CONTINUING ELIGIBILITY INSPECTION (CEI) REPORT
FOR HURRICANE & SHORE PROTECTION PROJECTS
Honolulu Engineer District
CEPOH-EC-T

1. Project Name: Ali'i Drive SPP
2. Date of Inspection: December 17, 2004
3. Inspection Personnel:

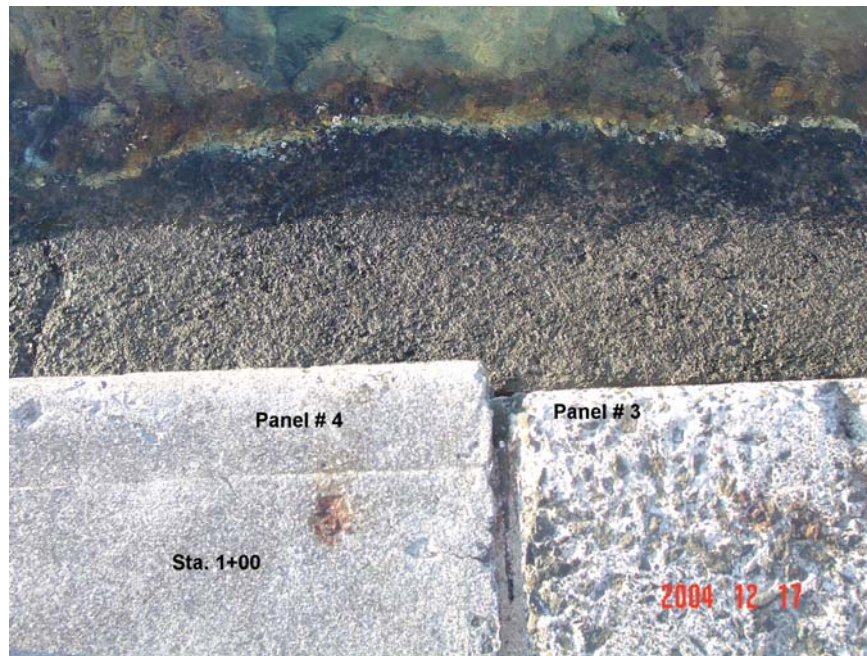
- c. Sta. 1+00, Panel # 4, Monitor the crest separation. This is an existing condition (reference photo). No Change.

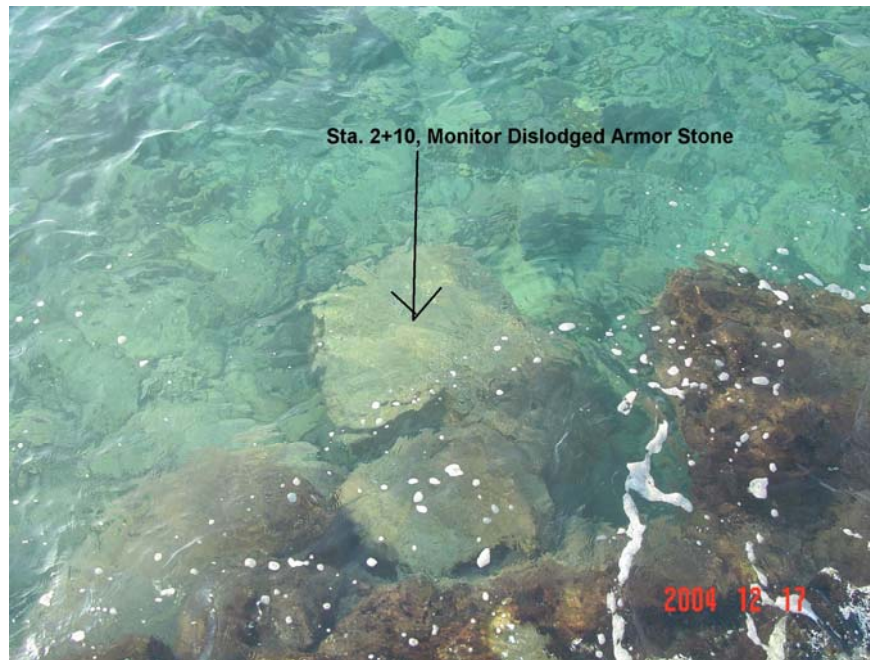
- d. Sta. 1+75, Panel # 5, Monitor the crest separation. This is a new condition (reference photo).

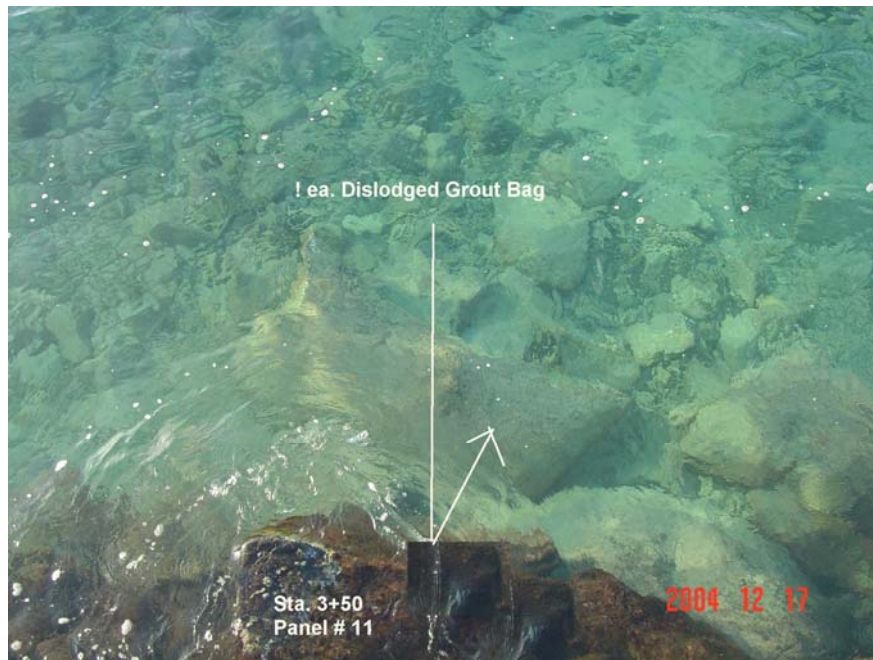
g. Sta. 2+36, Monitor this area for movement, 1 ea. dislocated grout bag.
